Product / Process Change Notification (PCN)

PCN #: PCN_UtRJ45LAN_20201118

Affected Series: WE-UtRJ45LAN; 7498xxx; 7499xxx; S1xxx

Before Change	After Change
Plastic material: PA46	Plastic material: PA9T

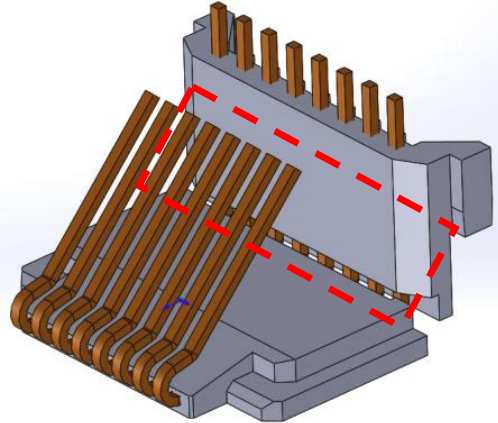
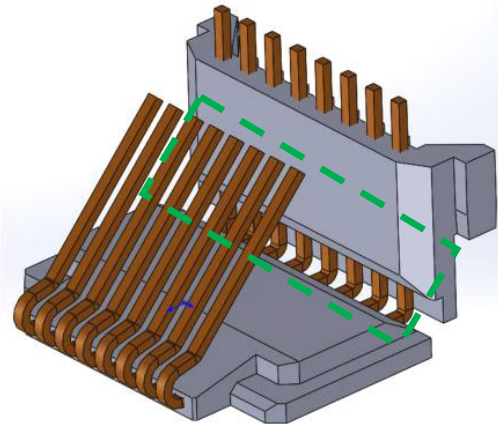
To improve the processability, Würth Elektronik will change the material of the J insert from PA46 to PA9T and improve the mechanical design.
